MONROE COUNTY PLAT COMMITTEE

November 17, 2022 4:00 pm

CASE NUMBER	PROPOSED NAME	DETAIL
SSS-22-7	Bowman Sliding Scale Subdivision	3-Lot Sliding Scale Subdivision Preliminary Plat

EXHIBIT 3: Bowman Sliding Scale Subdivision Preliminary Plat

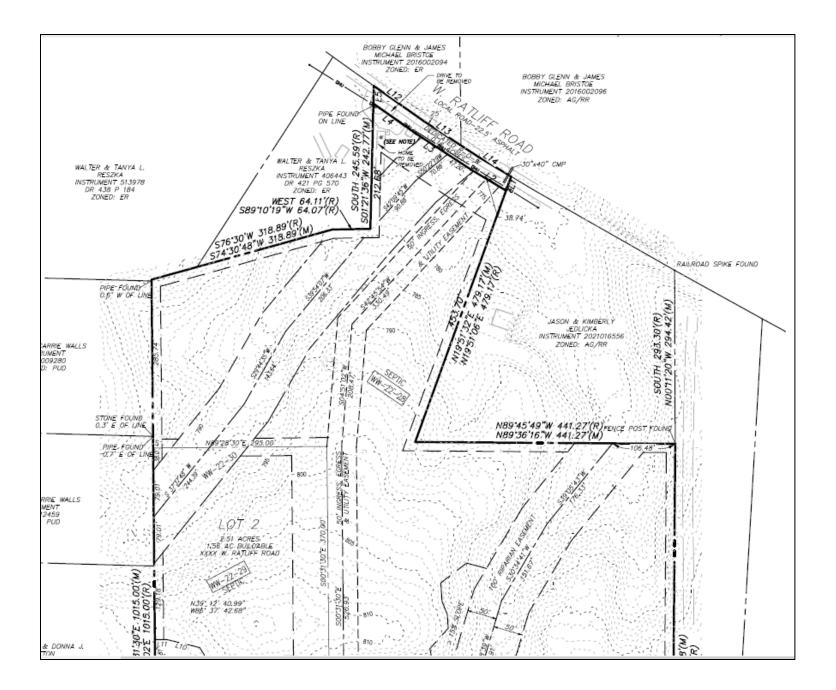
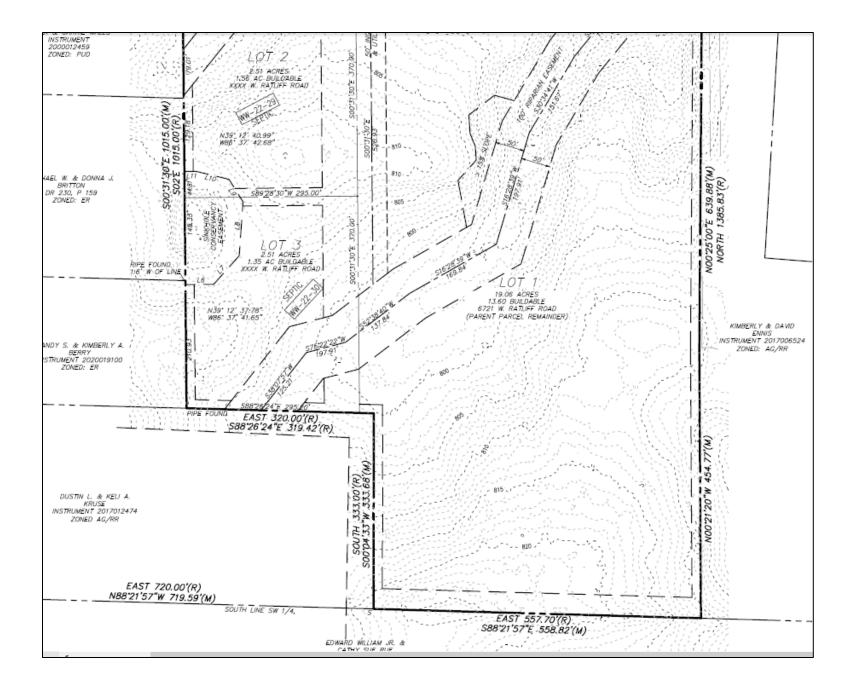
Existing driveway entrance on Lot #1 will need to be removed and connected to the proposed easement. Proposed easement will need to be located as far east as possible to meet sight distance requirements to the west.

КТ	Kelsey Thetonia			Remove Comment • Jul 11, 2022 at 10:44 am		
		Hi Doug, I uploaded a marked up version of the Bowman SSS plat. Please include 100' DEs centered on the flowlines. The lines I drew are approximate - please verify. If you'd like to suggest a different size easement let me know.				
	MC has a 4	42" pipe	arch under Ratliff Rd. at this location. New private driveways are required	d to comply with Ch. 761-6:

(E)	(E) Culverts for new driveways and for new private roads serving fewer than five houses shall be provided and designed so that:				
		(1)	flooding of existing local, collector, or arterial roads is not increased from any frequency flood,

(2)	flooding to habitable abodes is not increased,			
		(3)	the maximum off-site surcharge does not exceed one foot from any frequency flood, and			
		(4)	if the surcharge in a two year or a 100 year flood is over four feet, or if the berm height is over ten feet, the berm shall be designed to the standards specified by the County Engineer.			
	Existing private roads or driveways that are improved or serve new uses will be considered to be new private roads, and the culverts or bridges for these roads must meet the criteria described in this Ordinance. If not covered above, the maximum amount of surcharge may be established by the Board if the crossing is likely to cause off-site damages. In order to reduce maintenance resulting from debris jams, multiple culvert structures shall be allowed only in cases in which the likelihood of debris jams is small and the use of a single culvert is not feasible.
